**Engineering Evaluation
Of
Gambol Marine Shipyard
Proposed Business Plan**

Supplement to July 21, 2010 Report

October 21, 2010

**The Port of Los Angeles
425 South Palos Verdes Street
San Pedro, CA 90731**

720 Foot Dry Dock Orientation

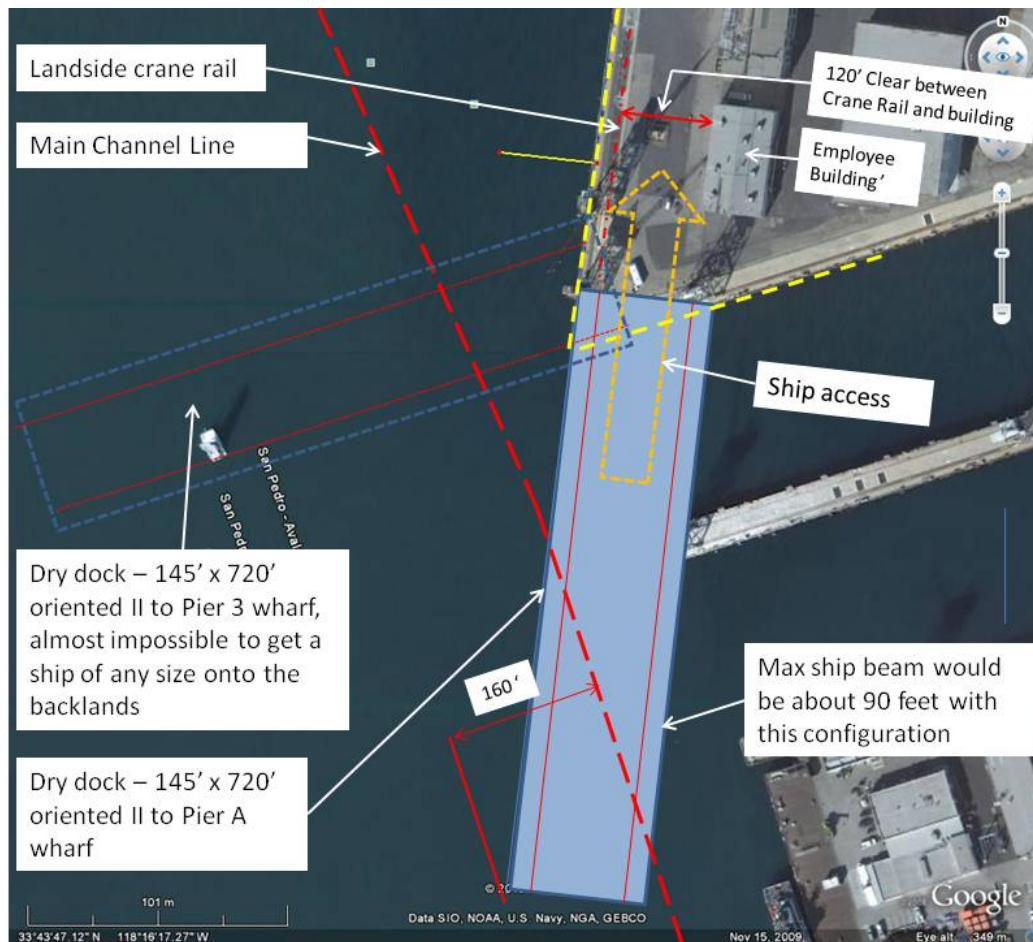
As indicated in the Gambol business plan, the dry dock (2+3) transfer operation appears to require that the dry dock align with a 150 foot wharf cut-off that allows the vessel to transfer to the work area adjacent to Pier 4. The dry dock is 145 feet in width and 720 feet in length. When in position, the dry dock extends into the Federal Channel a distance of 160 feet. This configuration has the potential to impact ship transit and will limit access to the north end of the Coast Guard wharf.

The available dry land work area is limited by the location of the Employee Office Building and the Outfitting building. The clear width from the landside crane rail and the buildings is 120 feet. It is estimated that the maximum vessel beam serviced is in the range of 80 to 90 feet.

Crane 2

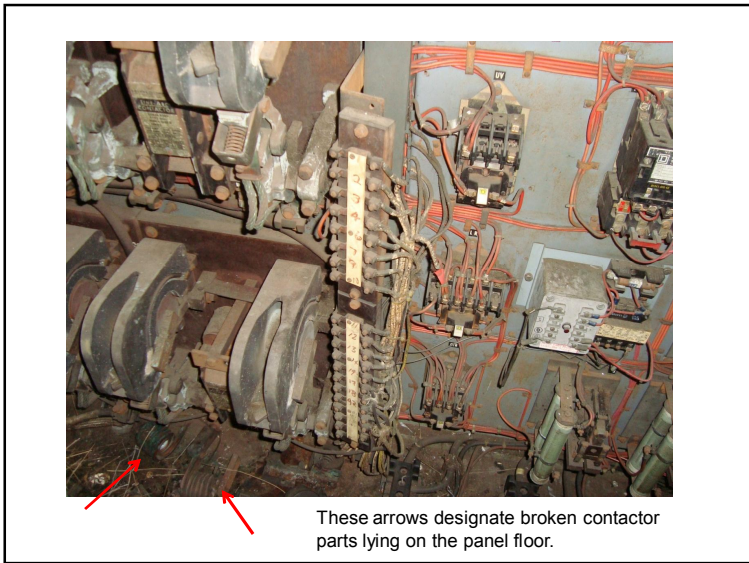
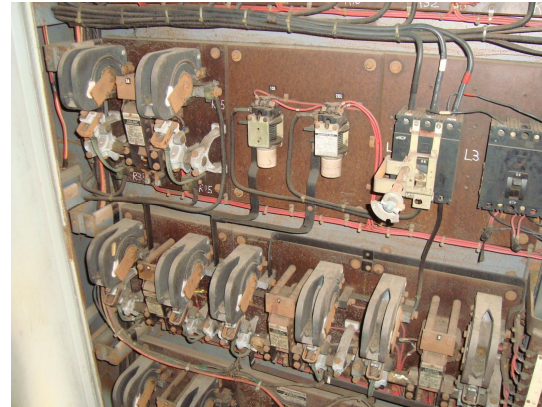
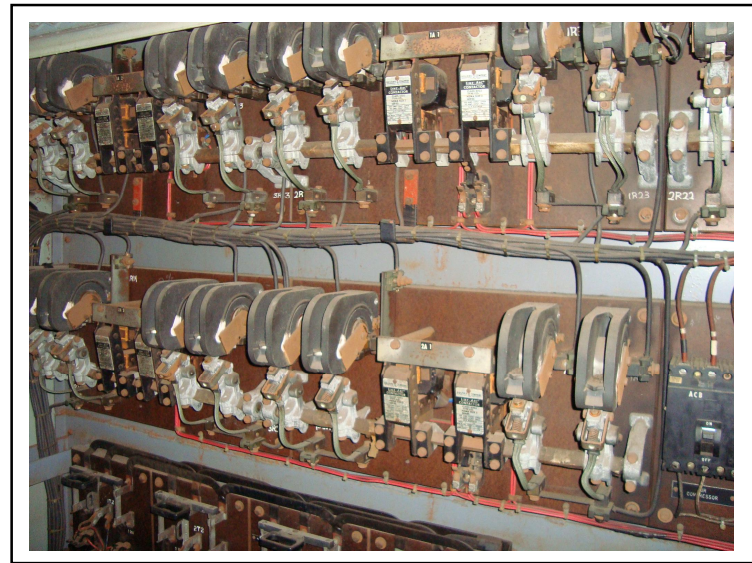
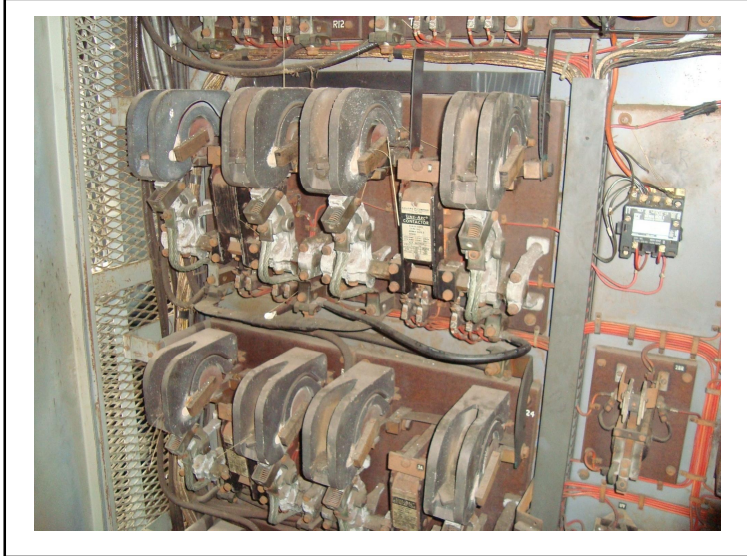
Electrical Panels for the Hoist, Boom Hoist, Swing and Gantry. The main concern of these panels is the functionality and lack of replacement parts.

These arrows designate broken contactor parts lying on the panel floor.

Rotator platform and wheels. The condition of these parts are unknown, but it is our feeling that this system would have to be reworked.

Crane 3

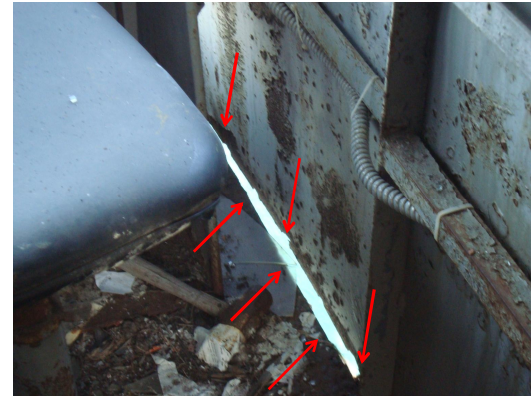
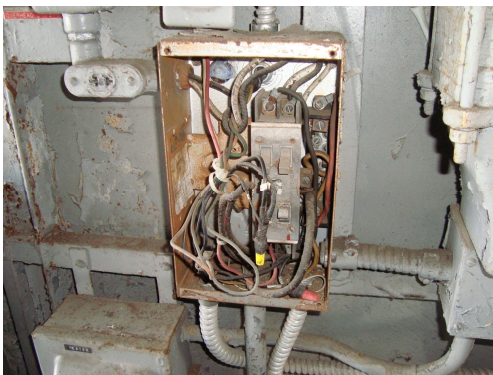
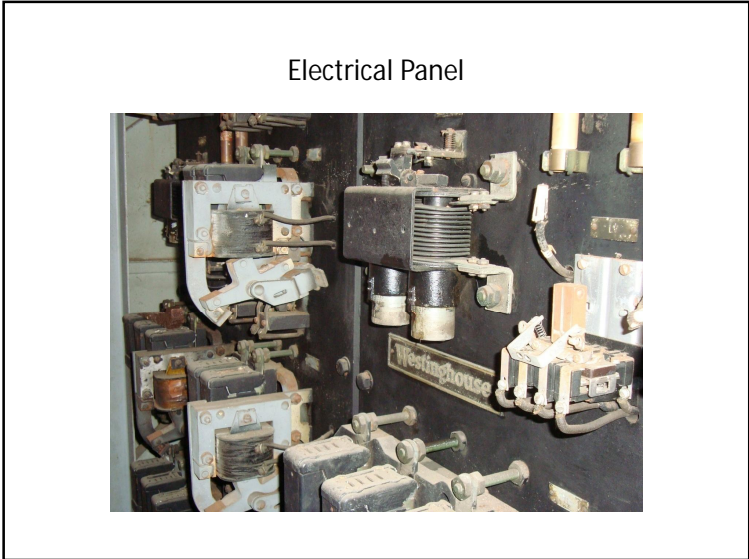
Our concern here is the structural integrity of the cab housing.
Light is visible into the cab.

Please notice the aged and exposed wiring in the operator's cab and machinery house.

Crane 4

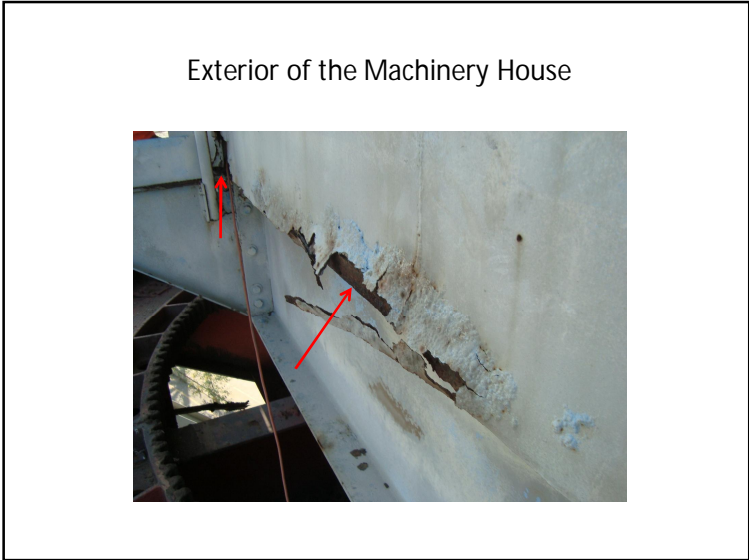
Please notice the extensive rust corrosion. The structural integrity of all of the components is in question.

Severe deterioration of machinery house roof and walls. Light is shining through the roof in multiple locations.

Notice the severe corrosion of critical components of the main hoist assembly.

Rotator motor assembly completely covered in rust and bird droppings.

Please notice the de-lamination of the structural steel.
This occurs in multiple areas of the crane.

- Heavy de-lamination of structural steel (legs and cross-members)
- Extensive corrosion of floor plating
- Extensive corrosion of machinery house walls and roof
- Recommend decommissioning

- Corrosion of all mechanical components beyond repair

Crane 7

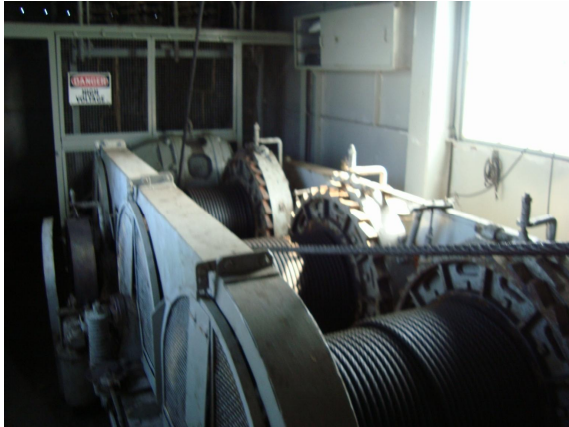
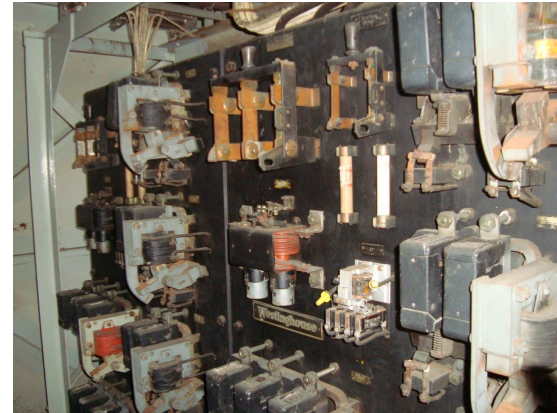
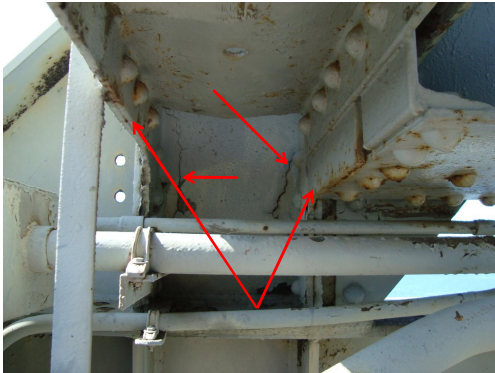
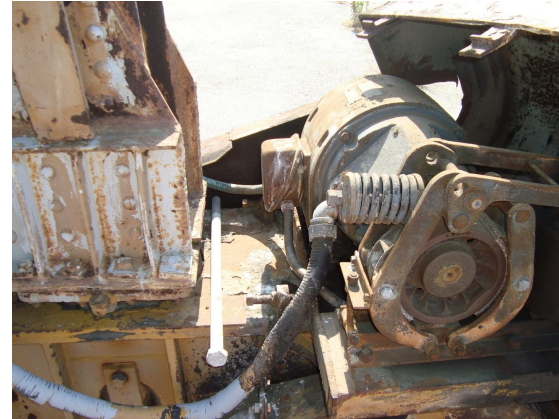
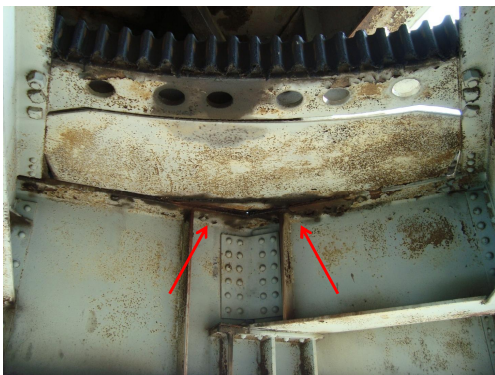
Please notice that these cables in the electrical panel are damaged and in need of repair.

Please notice the de-lamination of the structural steel.
Also, the rust is bulging out and cracking the paint.

The platform of the Rotator gears is rusting and de-laminating underneath.

Crane 9

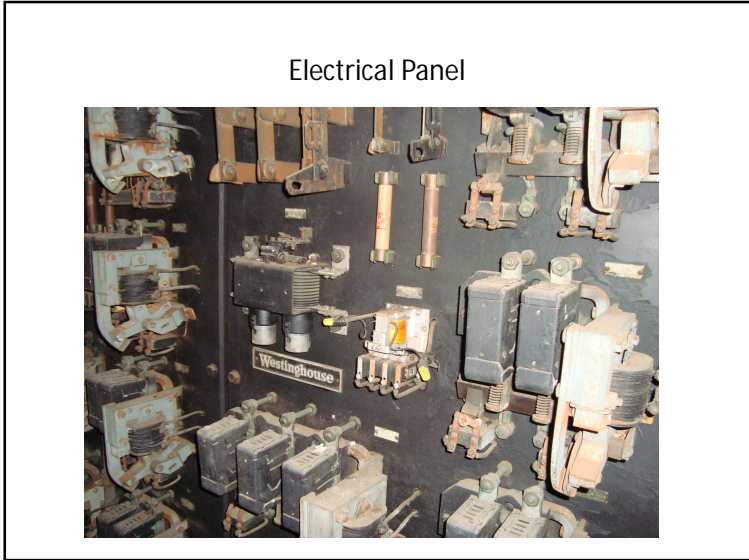
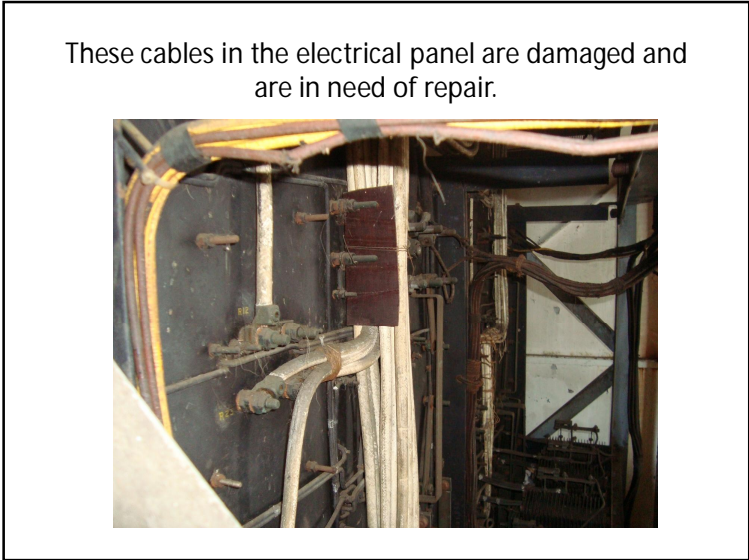
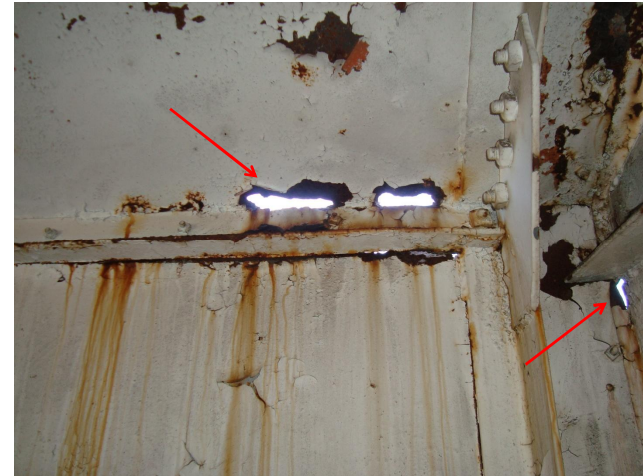
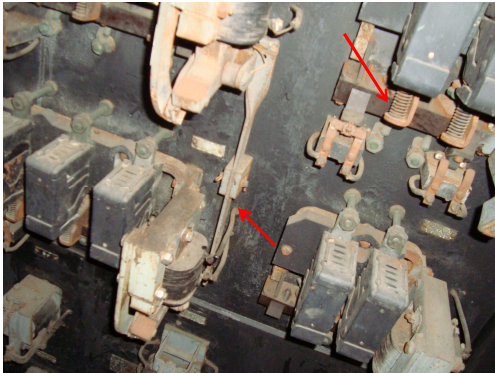
These cables in the electrical panel are damaged and are in need of repair.

With all the corrosion of the components we believe it is not possible to get these panels functional.

The structural integrity of the operator's cab is in question.

The boom sheave block is corroded and the bearings and sheaves are in question.
